**Technical Service
BULLETIN**

**ENGINE HOOD RELEASE CABLE
SPRING IMPROVEMENT**

'01 – '04 Highlander

BODY
BO011-04

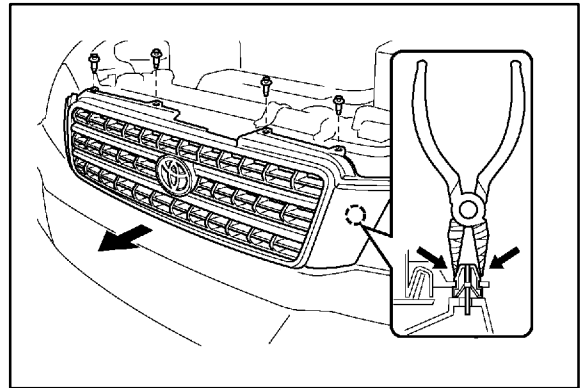
1. Remove radiator grille.
 - A. Remove the 4 clips from the top of the radiator grille.
 - B. Release the 2 side clips and remove the radiator grille.

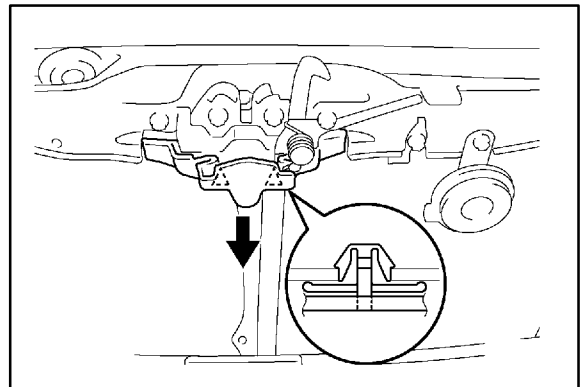
2. Using a screwdriver, disengage the clips and remove the hood lock release lever cover.

Tape the screwdriver tip before use.

3. Replace the engine hood release cable spring with the updated part (P/N 90506-09055).
4. Reinstall the hood lock release lever cover and radiator grille.
